Fort Calhoun Station  
P.O. Box 550  
Fort Calhoun, NE 68023

LIC-08-0067  
May 17, 2008

**SUBJECT: Response to Request for Additional Information re: Relief Request for Valve Replacement and Supplemental Information (TAC No. MD8722)**

Enclosure: Response to Draft Request for Additional Information

Figure 1: Location of the Indications on LCV-383-2

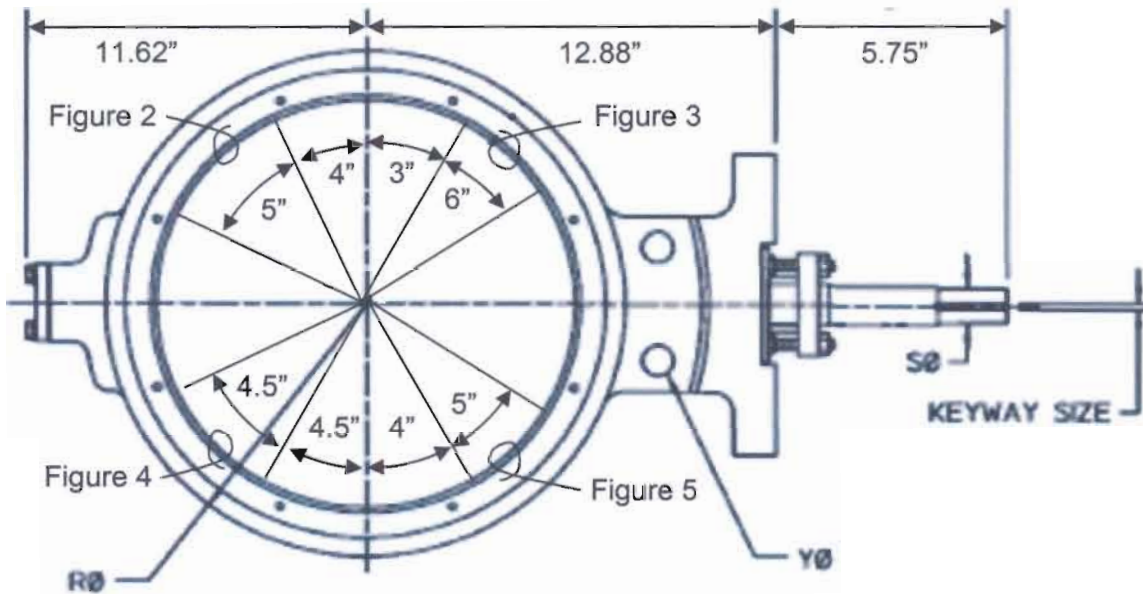
**Provide a detailed description of the flaw locations, flaw sizes, and number of indications. The indications were found by dye penetrant. Discuss why ultrasonic examination was not performed.**

Indications on LCV-383-2 were identified using liquid penetrant NDE examinations. Figure 1 below shows the location of the indications found on the valve interior surface. Figures 2 through 5 are photographs of the indications found in each quadrant. It should be noted that all indications were located on the inner surface of the valve body and are not in any flange seating surface, nor in any valve disc seating surface.
